Bulletin No.: PI0093A

Service Bulletin

Subject: Intermittent Click/Clunk Type Noise from Steering Column Area During Turns

Models: 2009-2012 Chevrolet Colorado
2009-2012 GMC Canyon

2443279

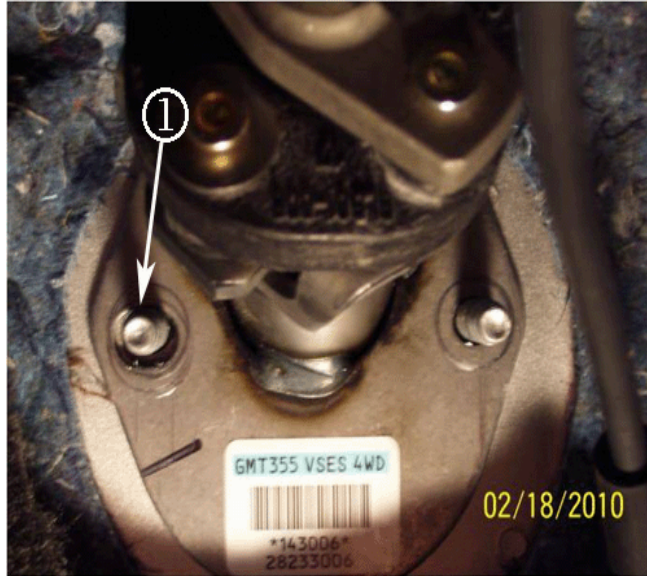
Some customers may comment on a click or clunk type noise from the steering column only when turning the steering wheel. They also may feel a slight pop from steering wheel or steering column housing.

The cause of this condition may be due to the toe plate stud orientation being at the bottom of the slot (1).

Remove the cowl stud fastener nuts located under the driver's dashboard by the pedals. Slightly shift the plate downward on the left side, causing the left stud to be at the top of the enlarged hole (1) as shown above. Reinstall the nuts and tighten to specification.
